JOHN PRICE SUBDIVISION
 LOCATED IN THE SOUTHEAST QUARTER OF SECTION 15,
 TOWNSHIP 6 NORTH, RANGE 3 WEST, SALT LAKE BASE AND MERIDIAN,
 WEBER COUNTY, UTAH
 MAY 2018

DEVELOPER: John Price 650 S 7900 W OGDEN, UT 84404 801-391-7169	S1 1	COUNTY RECORDER ENTRY NO. _____ FEE PAID _____ FILED FOR AND RECORDED _____ AT _____ IN BOOK _____ OF OFFICIAL _____ RECORDS, PAGE _____, RECORDED _____ FOR _____ COUNTY RECORDER _____ BY: _____
	CIVIL • LAND PLANNING MUNICIPAL • LAND SURVEYING 5150 SOUTH 375 EAST OGDEN, UT OFFICE: 801.476.0202, FAX: 801.476.0066

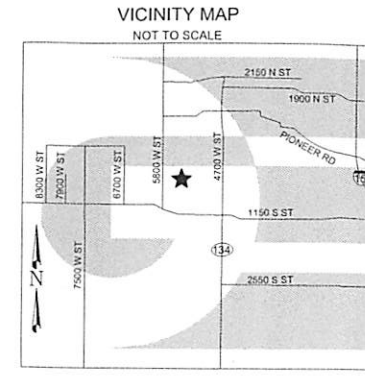
The surveyor making the plat shall certify that the surveyor "has placed monuments as represented on the plat". UCA 17-27a-604(4)(b)(iii)

The plat shall have a detailed description of all monuments found and each one shall be referenced on the plat including the type, size, condition, and location in reference to the surface of the ground as well as a description or graphic depiction of the markings, date, agency, entity, or surveyor as inscribed on the monument. WCO 45-3-3(b) DW

The Basis of Bearing sufficient for retracement shall be noted on the plat. WCO 106-1-8(c)(1)d basis of bearing does not match? DW

All easements observed, recorded in the Recorder's Office, or included in a preliminary title report unless legally vacated by all easement holders. WCO 106-1-8(c)(1)m address all title report easements.

The existing location, widths, and other dimensions of all existing or platted easements within and immediately adjacent (within 30') to the tract of land to be subdivided. WCO 106-1-5(a)(6) DW

The existing location, widths, and other dimensions of all existing or platted fence lines or other lines of occupation within or immediately adjacent to the tract to be subdivided. WCO 106-1-5(a)(6) DW

EXISTING 20.00' GAS & WATER LINE EASEMENT
ENTRY NUMBER?

DEVRON WILL BE SENDING YOU AN EMAIL PERTAINING TO THE LOCATION OF THIS CORNER

The subdivision boundary corners, lot corners, and centerline street monuments shall be noted on the final plat in conformance with county ordinance. WCO 106-1-8(c)(1)j

ADDRESS WILL BE GIVEN AT NEXT SUBMITTAL

WHAT IS THIS 30' EASEMENT? HOW FAR IS IT OFF THE PROPERTY LINE, IS IT PARALLEL?

The existing location, widths, and other dimensions of all existing or platted buildings and structures within and immediately adjacent (within 30') to the tract of land to be subdivided. WCO 106-1-5(a)(6) DW

WHAT IS THIS 30' EASEMENT?

NARRATIVE SEEMS TO HAVE A BASIS OF BEARING FOR A DIFFERENT SITE. ONCE THE EMAIL ABOUT THE SECTION CORNER FROM DEVRON HAS BEEN GIVEN PLEASE STATE WHICH CORNER LOCATION YOU WILL BE USING AND WHY, ALSO ANY INFORMATION ABOUT THE ACCESS AND SHOWING IT ON THE MAP.

All surveyed property corners or endpoints of property lines not already marked on the ground shall be marked pursuant to the Weber County Survey property corner detail sheet prior to the time of filing. WCO 45-3-5(a) DW

If the survey abuts or references a public or private right of way, subdivision, utility corridor, railroad, canal, river, etc. the survey narrative shall indicate what documentary, parcel, and tangible evidence was used and which legal principles of boundary establishment were used to reestablish the location of said features. WCO 45-3-4(a) DW
